STAFF REPORT - SITE PLAN REVIEW

Date: 8/8/2018		Planner: Alice Correa		Case No: P-22-18 – FOUNDATION ONLY	
PROPERTY & APPLICANT INFORMATION:					
Project Name/Proposed Use: CFD1 Lakeview Fire Station-Foundation Only			Property Address: 4305 N Lakeshore Dr.		
Applicant: Caddo Fire District 1			Owner: Caddo Fire District 1		
Prior Cases: Click here to enter prior case numbers.			Additional Requests: Multiple variances (BAP-13-18)		
City Council District: N/A			Parish Commission District: 2/Johnson		
REVIEWED BY:					
<input type="checkbox"/> Engineering – Streets & R.O.W. (<input checked="" type="checkbox"/> N/A)		<input type="checkbox"/> Engineering – Stormwater & Drainage (<input checked="" type="checkbox"/> N/A)		<input type="checkbox"/> Fire Prevention (<input checked="" type="checkbox"/> N/A)	
<input checked="" type="checkbox"/> Caddo Parish Public Works (<input type="checkbox"/> N/A)		<input type="checkbox"/> LA Department of Transportation (<input checked="" type="checkbox"/> N/A)		<input type="checkbox"/> Alcohol Beverage Office (<input checked="" type="checkbox"/> N/A)

PROJECT NAME
CADDO FIRE DISTRICT 1
LAKEVIEW STATION #5 RENOVATIONS
4305 LAKESHORE DRIVE, SHREVEPORT, LA

SHEET TITLE
FOUNDATION PLAN & DETAILS

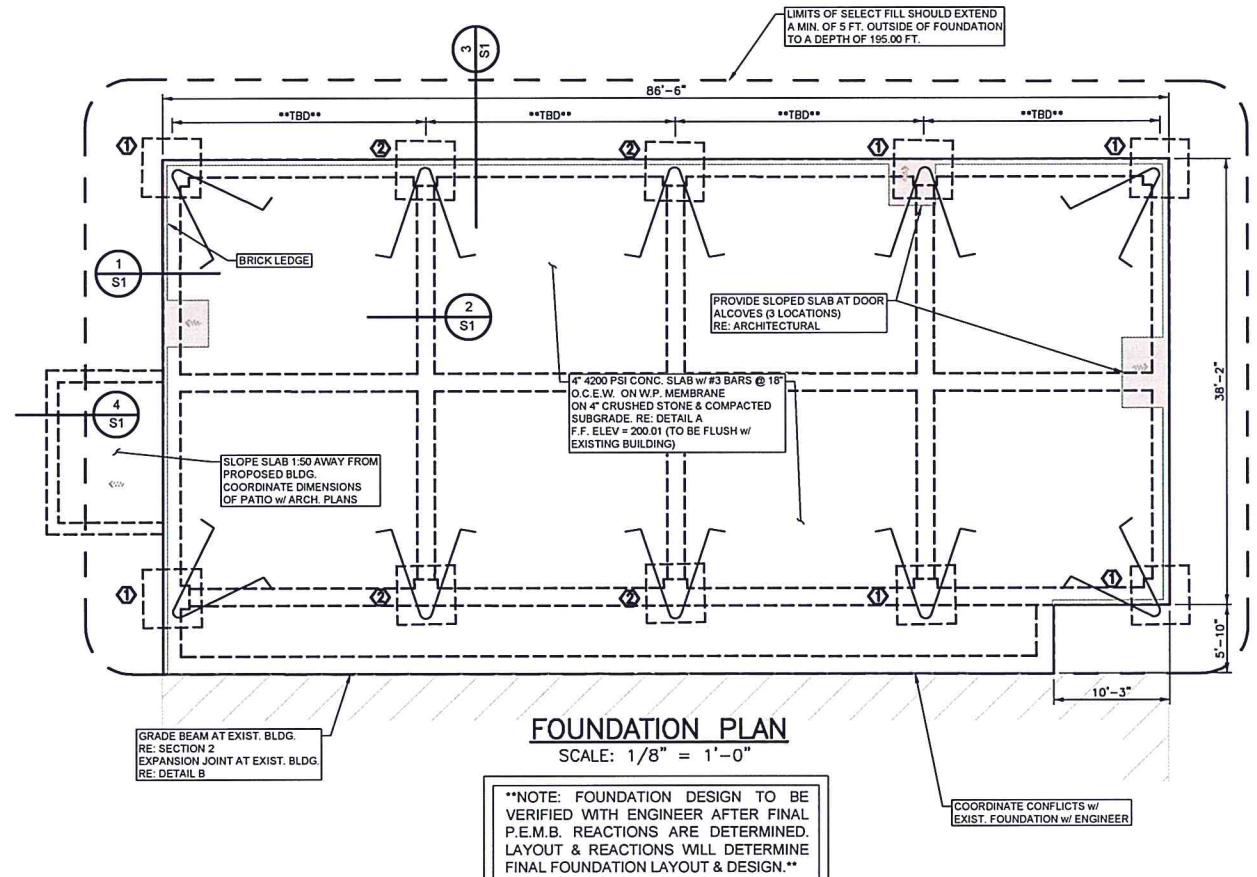
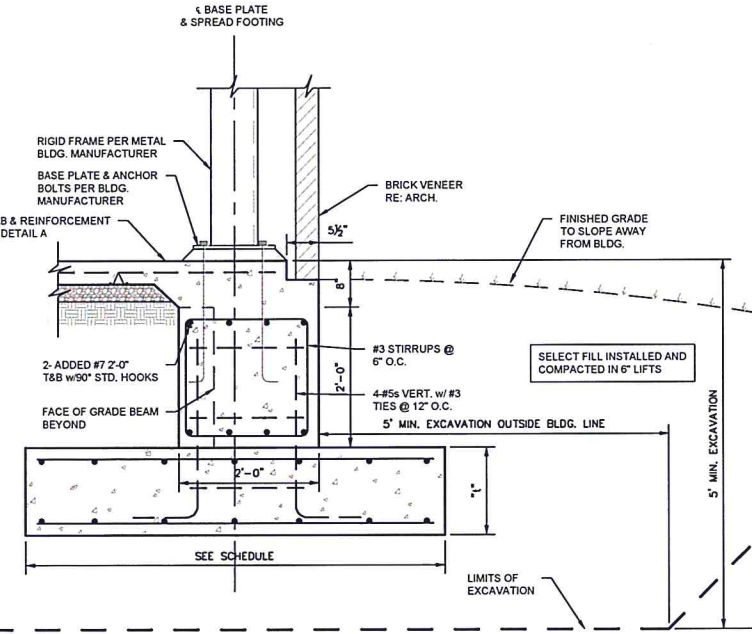
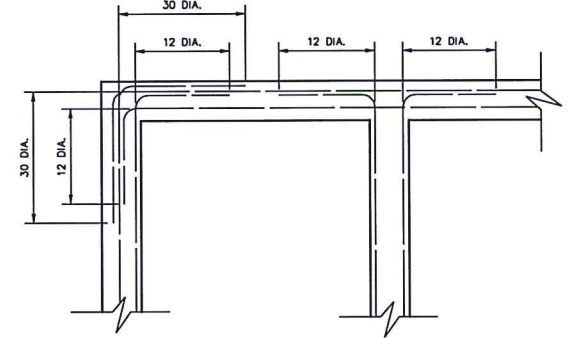
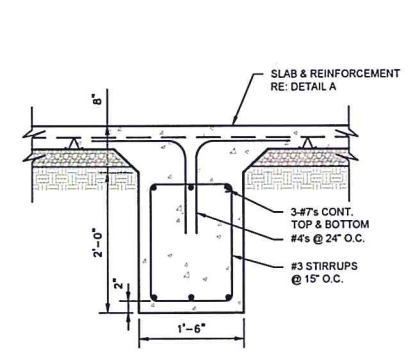
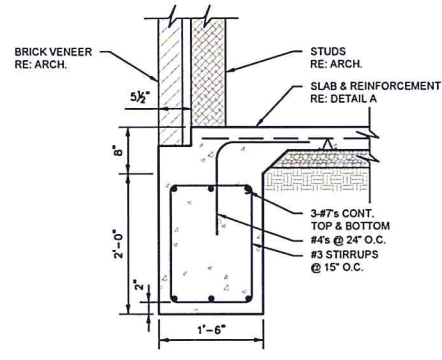
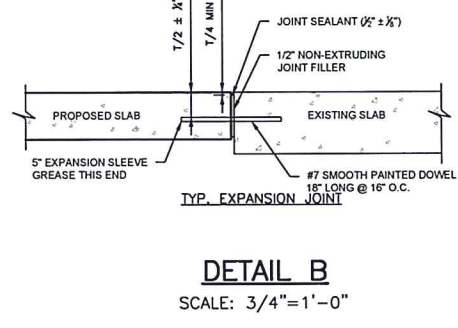
* Foundation plan approval only. Administrative site plan approval required prior to the issuance of any other permits.
